Project	IEEE 802.16 Broadband Wireless Access Working Group < http://ieee802.org/16 >	
Title	Enhancing the Procedure Flow in WirelessMAN-CX Operating Stage----Methods to Fairly Use Channels in WirelessMAN-CX Operating Stage	
Date Submitted	2007-03-05	
Source(s)	<p>Liwen Chu STMicroelectronics 1060 East Brokaw Road San Jose, CA, USA</p> <p>George Vlantis STMicroelectronics 1060 East Brokaw Road San Jose, CA, USA</p>	<p>Voice: 1-408-467-8436 Fax: 1-408-452-0278 liwen.chu@st.com</p> <p>Voice: 1-408-467-8436 Fax: 1-408-452-0278 george.vlantis@st.com</p>
Re:		
Abstract		
Purpose	To consolidate the working document	
Notice	This document has been prepared to assist IEEE 802.16. It is offered as a basis for discussion and is not binding on the contributing individual(s) or organization(s). The material in this document is subject to change in form and content after further study. The contributor(s) reserve(s) the right to add, amend or withdraw material contained herein.

Methods to Fairly Use Channels in WirelessMAN-CX Operating Stage

Change Figure h17 as follows:

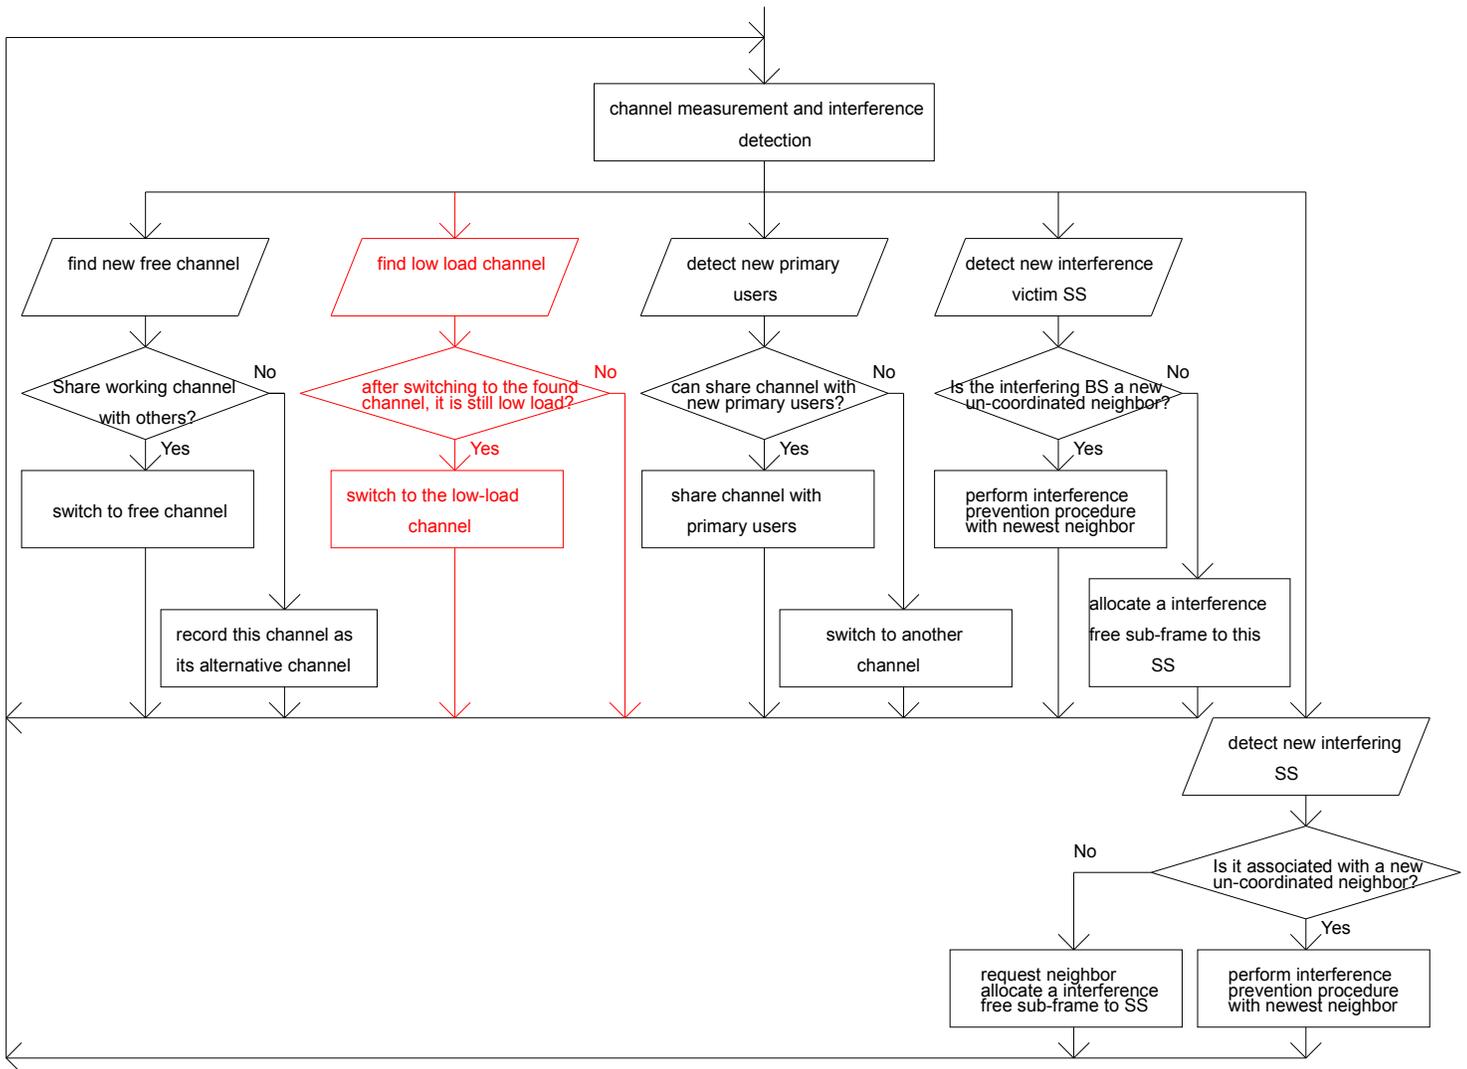
The higher priorities (smaller backoff periods) are given to the systems in more congested channels. The Systems with 3 (maximal value) overlapping neighbors working in the same channel has the smaller backoff window. The Systems with 2 overlapping neighbors working in the same channel has the larger backoff window. The systems trying to switch to a new channel select a random numbers from the backoff windows. A BS will generate a backoff period before it tries to switch its working channel to an idle channel or a channel with fewer systems working in it. During the backoff procedure, the BS and its associated SSs shall allocate more resource to measure the channel that it tries to switch to. In case another BS switch to that channel, the BS shall stop the backoff procedure. If the channel is still a sparsely used channel, the BS may start another backoff procedure or keep stay in the original working channel.
